**Coal Combustion Waste Impoundment
Round 7 - Dam Assessment Report (Site #009)**

***Nearman Creek Power Station
Coal Ash Pond Dike
Kansas City Board of Public Utilities
Kansas City, Kansas***

Dewberry & Davis, LLC
Fairfax, Virginia

Under Contract Number: EP-09W001727
October 2010

BOTTOM ASH POND DISCHARGE STRUCTURES
TWO REQUIRED
NO SCALE

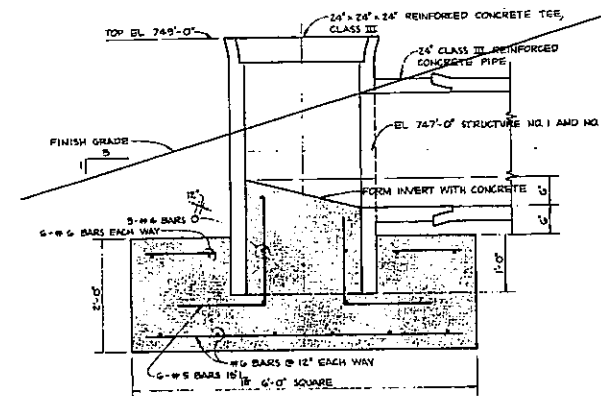
Seepage was occurring through the 30” reinforced concrete outlet. This outlet is equipped with both a manual valve system and an inflatable balloon system. The observed leakage raises questions about the overall reliability of these closure mechanisms. See recommendations in Section 1.2.5.

The original design included a 30-inch mid-depth discharge pipe regulated with a mechanical gate. The purpose of this pipe was to permit inflow into the pond in case of flooding to help stabilize the embankments during construction and prior to operational start-up. This pipe has reportedly been closed since construction of the pond was completed. When the mechanical gate started leaking, plant management decided to close this pipe using an inflatable balloon system. However, a small amount of leakage was observed from this pipe during the site visit, raising questions regarding the reliability of these closure mechanisms.

Continued efforts to locate the original slope stability design documentation are recommended. If the original documentation cannot be located within a reasonable period of time, a geotechnical engineering evaluation is recommended to verify the embankment has an acceptable factor of safety for all anticipated loading conditions, including seismic loading.
